Addendum No. 2

Project: St. Patrick Catholic Church
Bid Set #2
6111 Morrill Avenue
Lincoln NE, 68507

Date Issued: January 21, 2014

Issued By: Brian Semerad, Project Manager
Kingery Construction Co.

A102

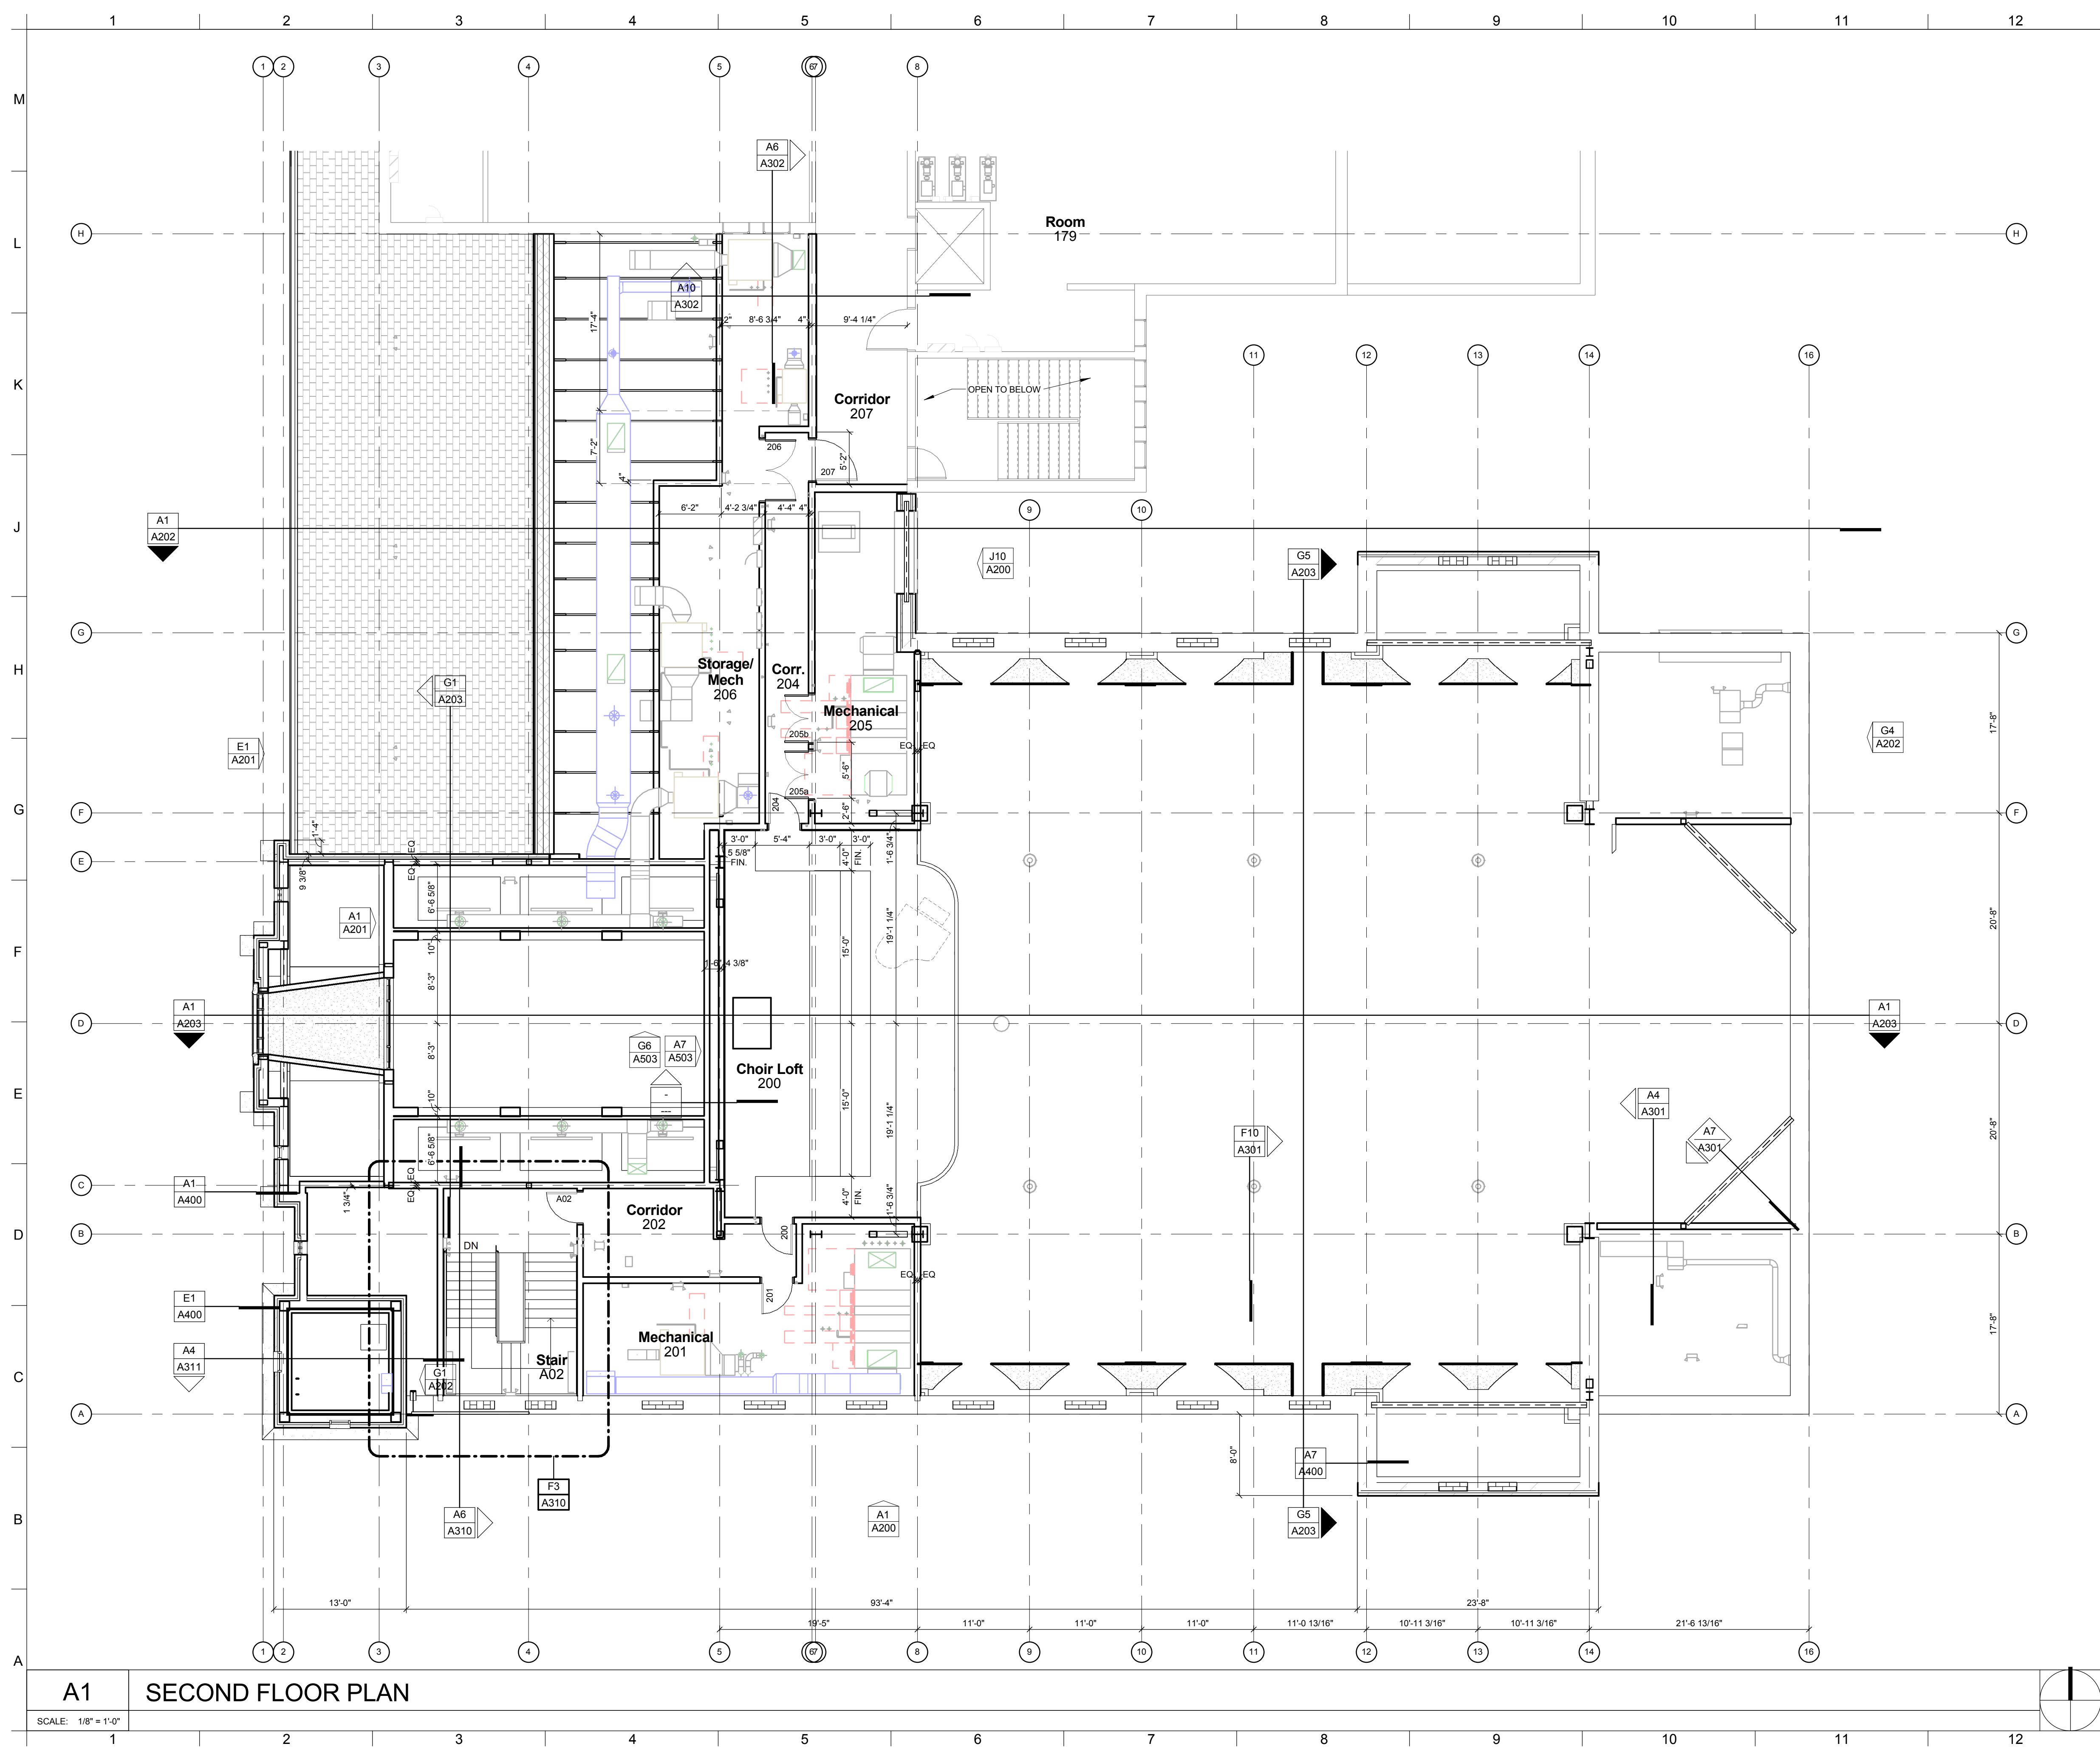
A. This drawing is attached for information only and is not the final version. Final version of this drawing will be issued with a later bid set. This drawing provides dimensions of the choir loft risers.

RELAY ONE-LINE - ADDENDUM 2

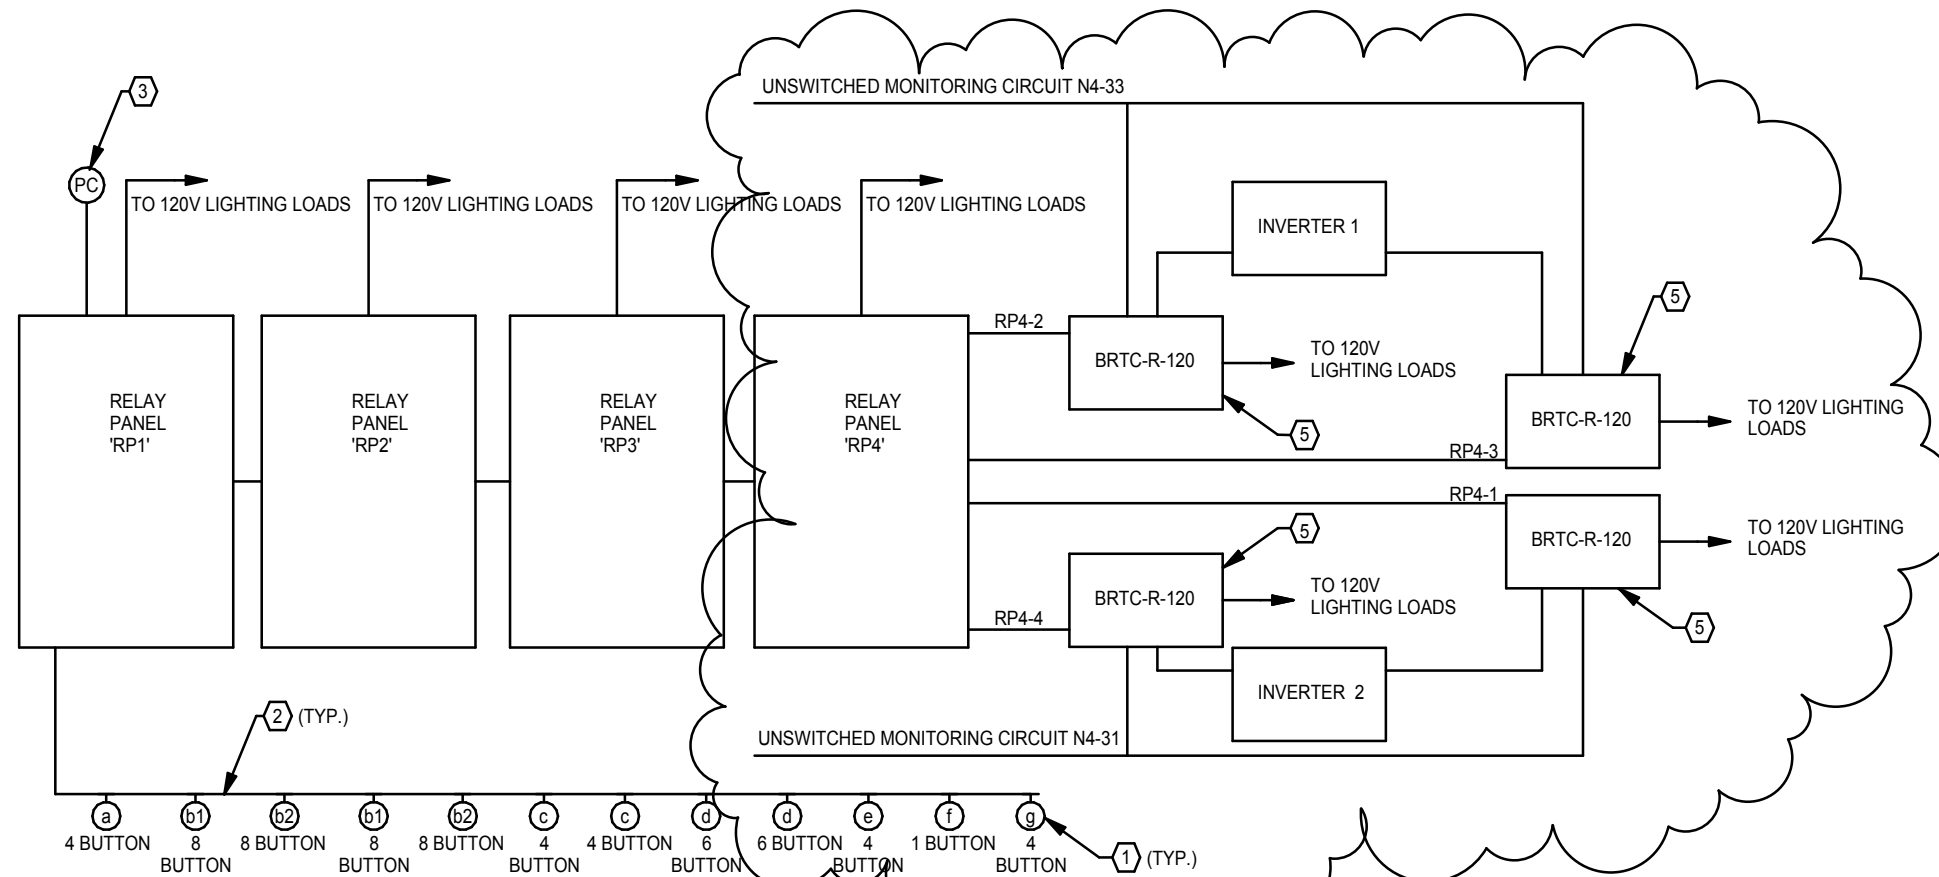
6. Refer to sketch E401-5 for updated diagram.
